ADDENDUM #01

DATE:	09-17-2026		
PROJECT:	Kollar Pond Phase 1	PROJECT #:	24255 CH
LOCATION:	Streamwood, IL		
OWNER:	Village of Streamwood	BID REQUEST #:	
CONSULTANT:	Confluence		
CONTACT:	Mr. Devon Dillinger, PLA, ASLA, SITES AP 307 N Michigan Ave, Suite 601 Chicago, Illinois, 60601 ddillinger@thinkconfluence.com

This Addendum forms a part of the Contract Documents and is issued prior to receiving bids for the project. The addendum modifies the original bidding documents dated July 31, 2026, with amendments and additions noted below. The bidder shall note receipt and make acknowledgement of this addendum on the Bid Proposal Form, incorporating these provisions in the bid. All items in conflict with this addendum are hereby deleted.

LP100

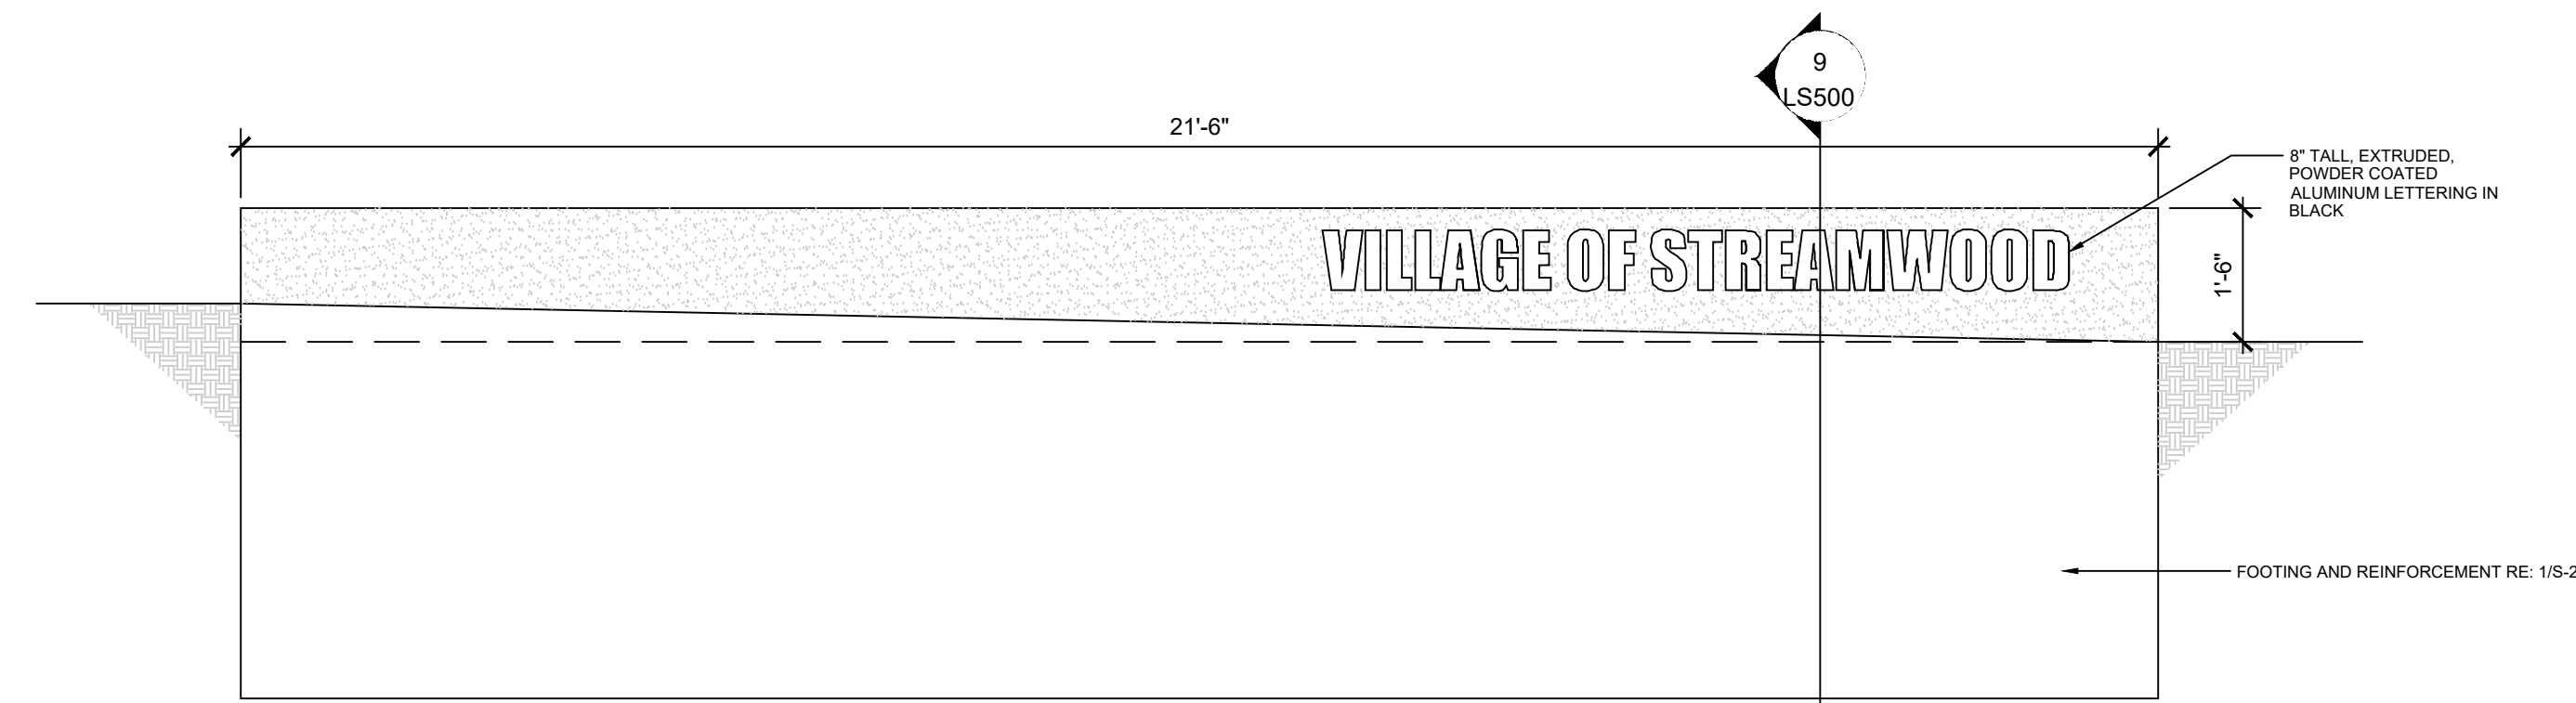
- Sheet GN000
 - **ADD** C401 to Drawing Sheet Index
- Sheet LP100
 - **ADD** American Cranberrybush, *Viburnum trilobum* (VA) and QTY of 56 to plant schedule
- Sheet LS500
 - **ADD** dimensions and labels to 7/LS500
 - **ADD** dimensions to 14/LS500
- Sheet C401
 - **ADD** sheet

27) Question: "There are plants in the landscape plan labeled "VA" but that designation is not in the plant material table. Can you clarify?" (Received: 09-16-2026)

a. ANSWER: VA is the label for Viburnum trilobum, American Cranberrybush. Refer to LP100.
